Proposed change to the King Charles III England Coast Path (KCIIECP) at Sutton Hoo and Methersgate, Suffolk

Natural England's Variation Report to the Secretary of State

Coastal Access Variation Report FFB-VR23
May 2025

Table 2.3.1: Map FFB 4a - Wilford Bridge to Little Haugh

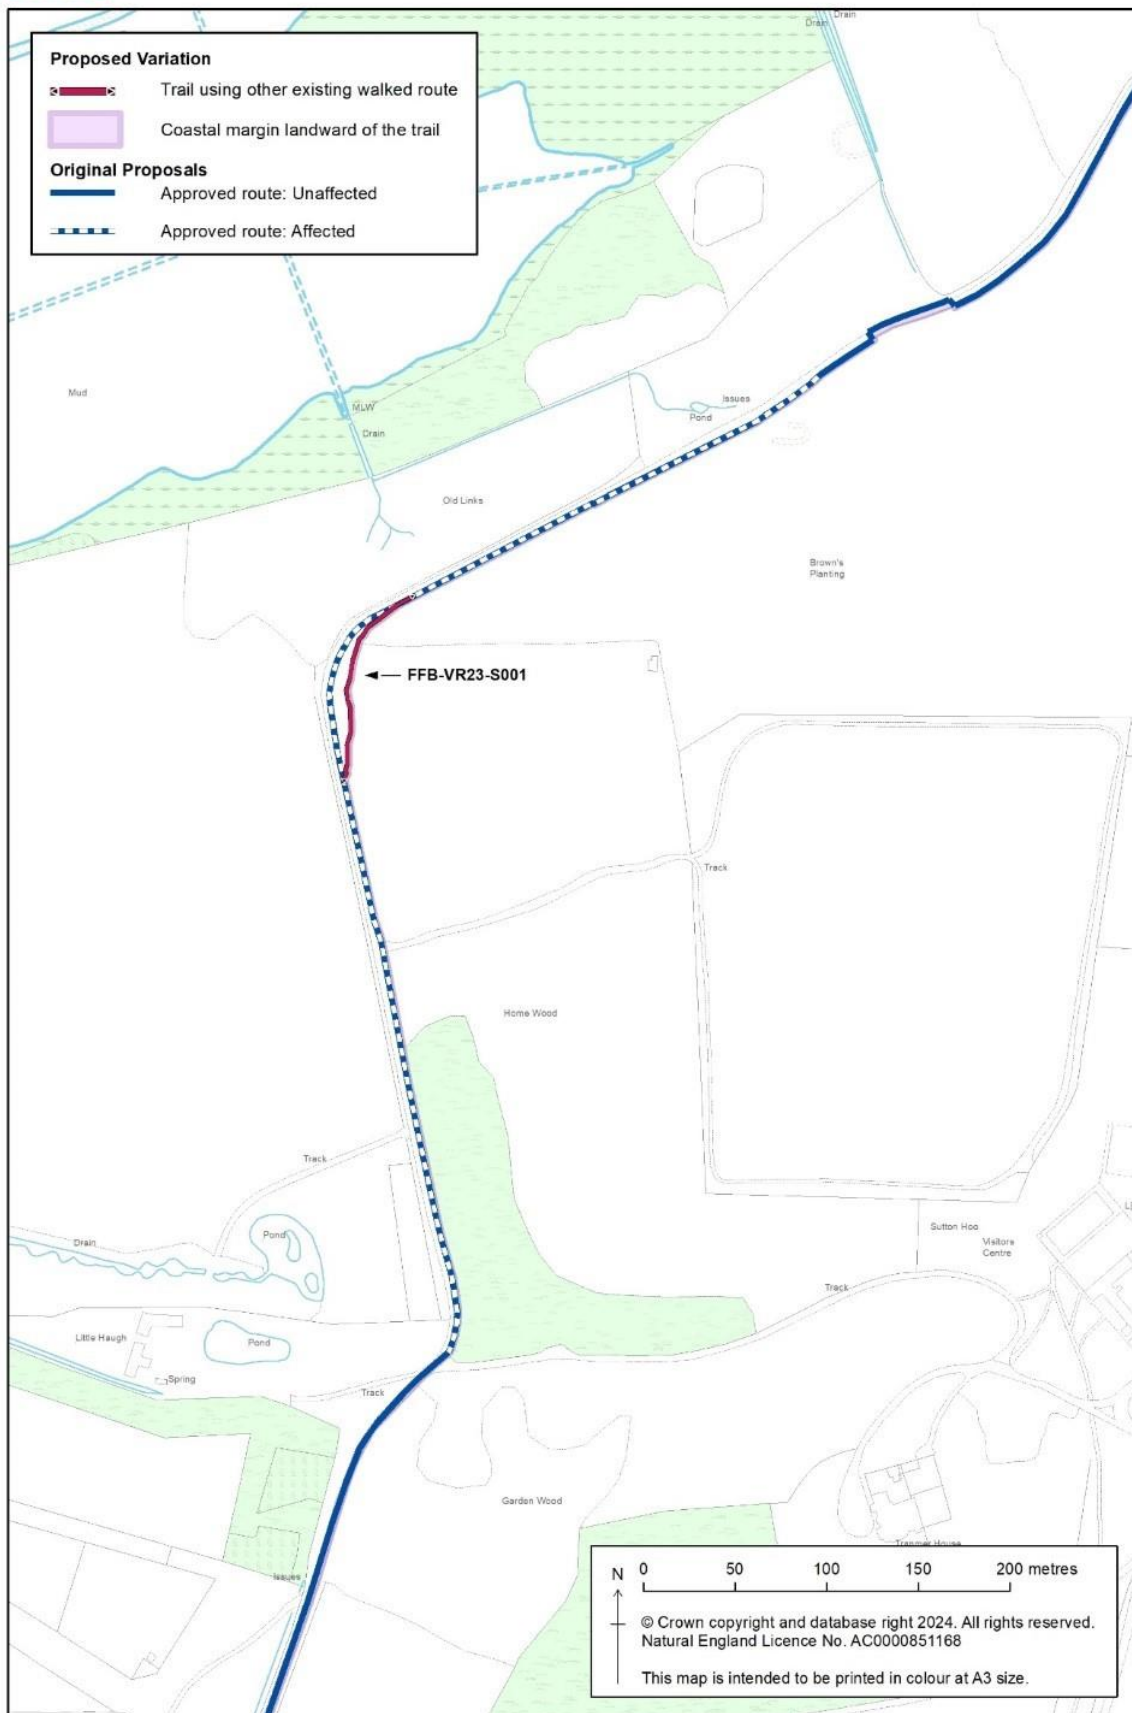
2.1.1 The approved alignment of the route is along the vegetated verge of a tarmac track on the National Trust's Sutton Hoo Estate. Since approval of the route Natural England had a site visit with Suffolk County Council and the National Trust and we have agreed to adjust the route slightly to follow the National Trust's permissive route for its visitors. This will take walkers away from a sharp turn on the track, with limited visibility for traffic, and instead go landward of the approved route through trees and grassland. The landowner supports this proposed variation.

2.1.2 The approved route FFB-4-S009 is aligned on a grass verge (see Maps VR23a and VR23b), alongside a tarmac track.

2.1.3 The route would be varied at the bend, on to a route that is up to nine metres inland from the approved route. It is an existing walked route that is signed by the National Trust as a permissive route. The surface is compacted soil.

- takes visitors away from a bend in a road, and away from traffic.
- would follow an existing signed path through woodland and on grassland.
- follows a route similar to the existing approved route.
- is on compacted soil.
